**VENICE CROSSING**  
**MINOR PRELIMINARY PLAT**  
**&**  
**DESIGN ALTERNATIVE**  
**PETITION NO. 25-16PP&25-17DA**

OWNER/APPLICANT: 2001 LAUREL, LLC AND RANDALL C. HURT, JOSEPH W., HURT AND MARY H. MCMULLEN  
AGENT: JACKSON R. BOONE, ESQ., BOONE LAW FIRM

<b>Address:</b>	<b>2001 Laurel Road</b>
<b>Request Design Alternative:</b>	<b>Requesting Amendment to Type 1 Buffer Along Northern property line approved through Design Alternative Petition 23-60DA</b>
<b>Request Minor Preliminary Plat Amendment:</b>	<b>Modification to Stormwater Ponds, Lots, Buffers and Internal Roads</b>
<b>Applicant:</b>	<b>2001 Laurel, LLC and Randall C. Hurt, Joseph W., Hurt and Mary H. McMullen</b>
<b>Agent:</b>	<b>Jackson R. Boone, Esq, Boone Law Firm</b>
<b>Parcel ID:</b>	<b>0380-11-0002, 0380-14-0002, 0380-02-0001, 0380-09-0001, 0380-16-0001 and 0380-16-0003</b>
<b>Parcel Size:</b>	<b>82.81 ± acres</b>
<b>Future Land Use:</b>	<b>Mixed Use Corridor</b>
<b>Zoning:</b>	<b>Commercial, General (CG)</b>
<b>Comprehensive Plan Neighborhood:</b>	<b>Laurel Road Neighborhood</b>
<b>Application Date:</b>	<b>March 27, 2025</b>

# MODIFICATION TO PRELIMINARY PLAT

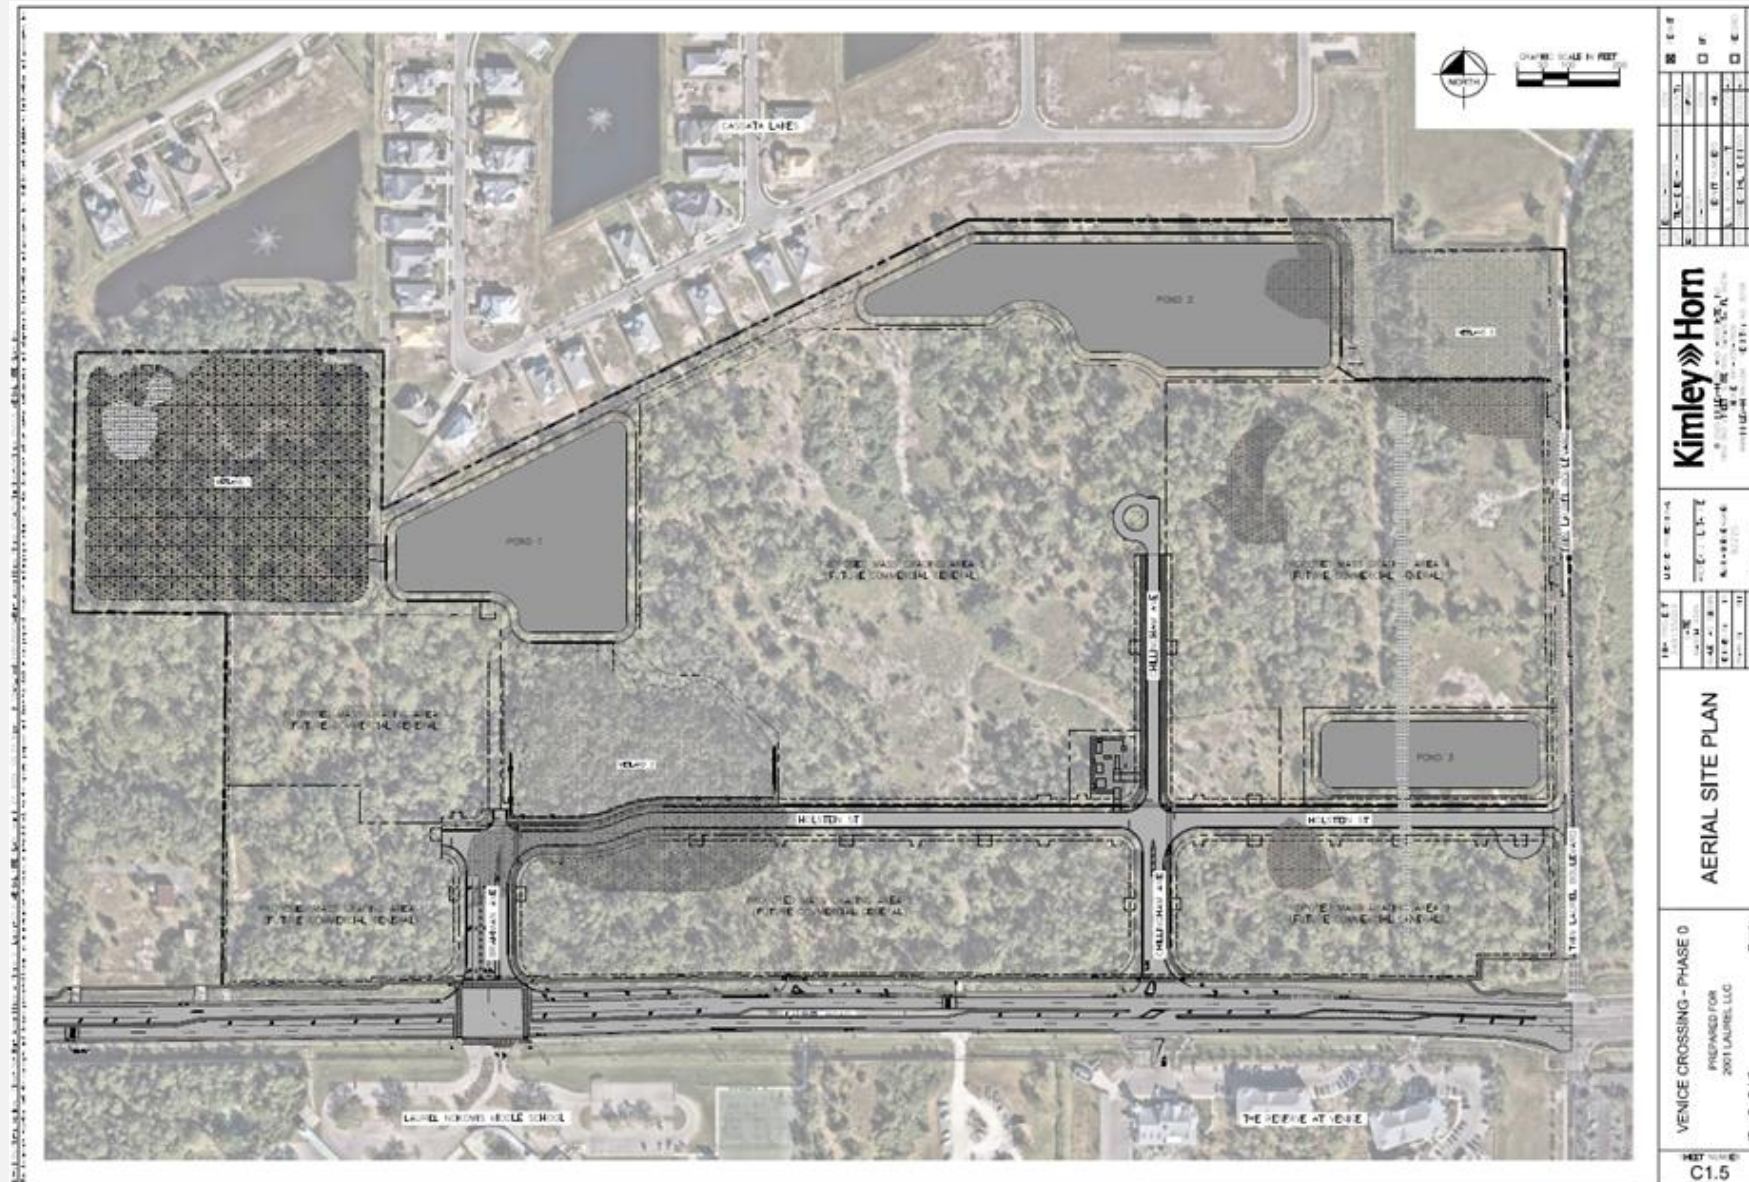
- Since the approval of the last Minor Preliminary Plat Amendment 24-45PP, the applicant has indicated the need to make some minor adjustments:
  - Lot configurations and land use areas;
  - Buffering along the northern boundary;
  - Modifications to the stormwater ponds and wetland area 3 (no decrease in size), and;
  - Minor shifts to the access points along Twin Laurel Boulevard.
- The requested changes are needed with the elimination of the approved multi-family project and changing market conditions.
- These modifications are minor and would typically be approved administratively; however, given the public safety purpose of proper access management, combined with the design alternative requested for the northern buffer, the Zoning Administrator has determined that a public hearing for consideration by the Planning Commission is required.

# DEPICTION OF AREAS REQUESTED FOR DESIGN ALTERNATIVE

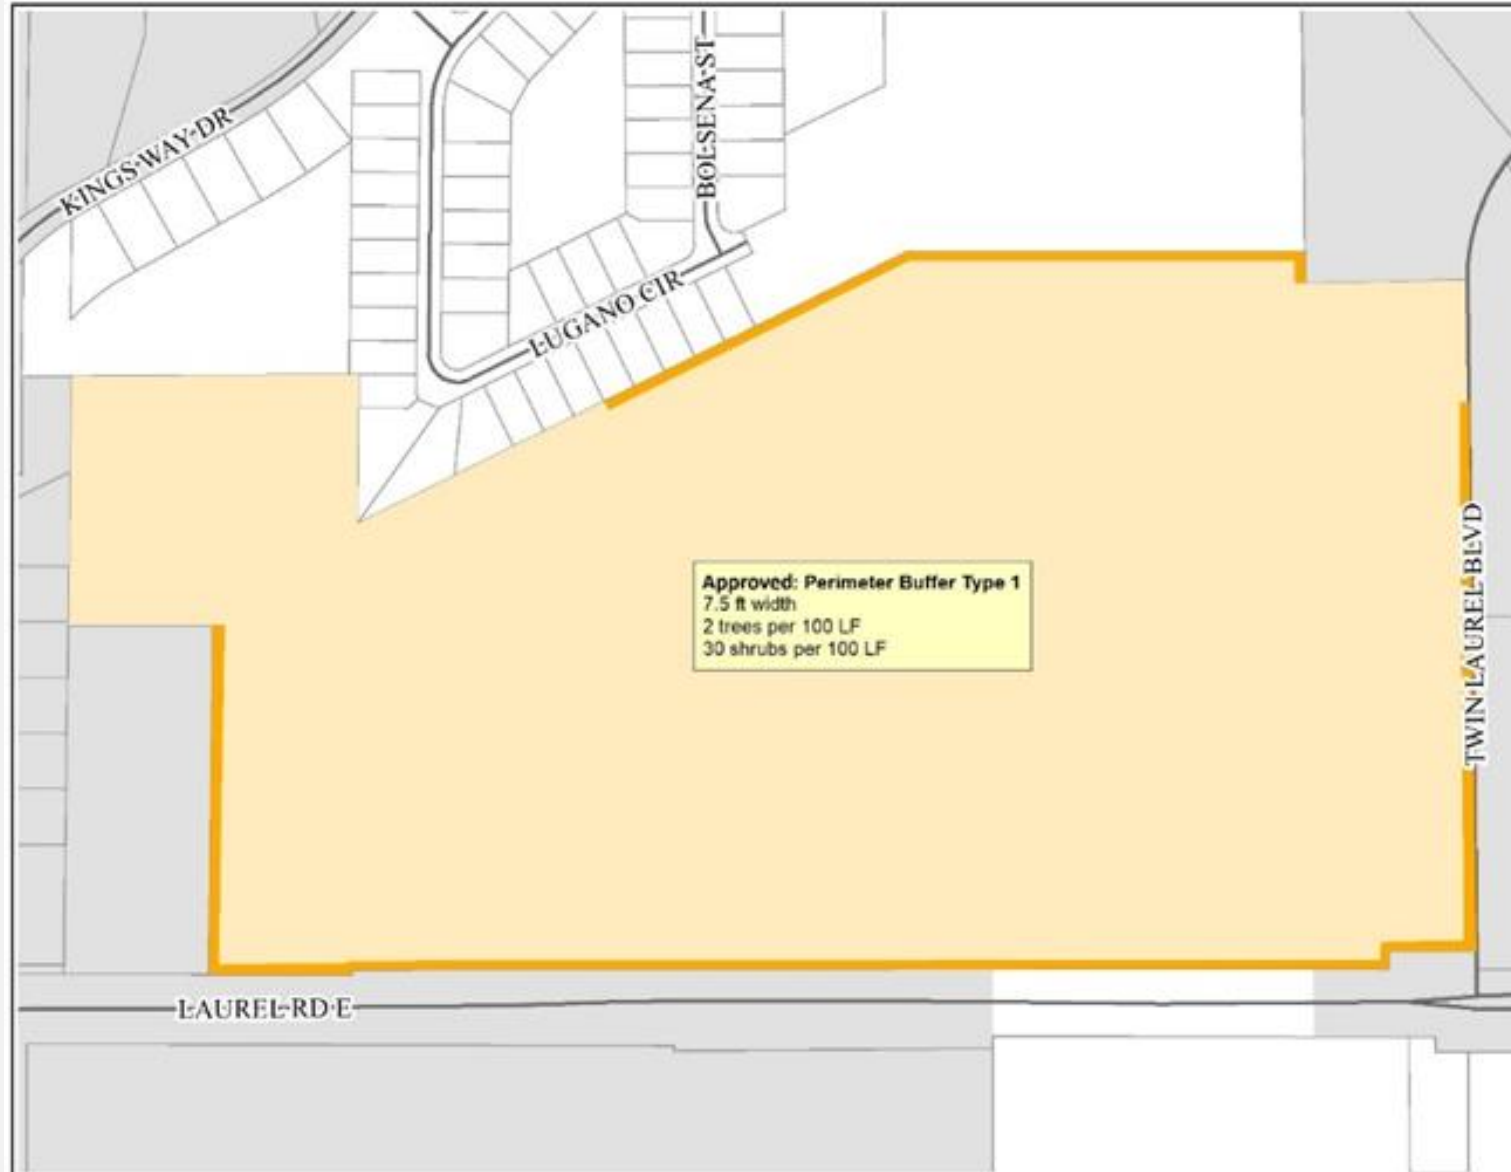
- The Design Alternative is requesting relief from the perimeter buffers of Section 4.2 and 4.3 Perimeter Buffer Types for the commercial subdivision.
- The applicant proposes maintaining a Type 1 buffer along the south, east and west boundaries of the subdivision. For the wetland areas no perimeter buffer would be required, consistent with the approved Design Alternative No. 23-60DA.
- For the north boundary adjacent to Cassata Lakes, the applicant proposes a 25' wide buffer. In this buffer, the applicant is proposing to plant canopy and understory trees that are twice the caliper required by the code in lieu of a 6' wall, as well as shrubs, which would typically be required by a greater perimeter buffer type, while maintaining the standard of no required buffer in areas where a wetland is located on the perimeter.
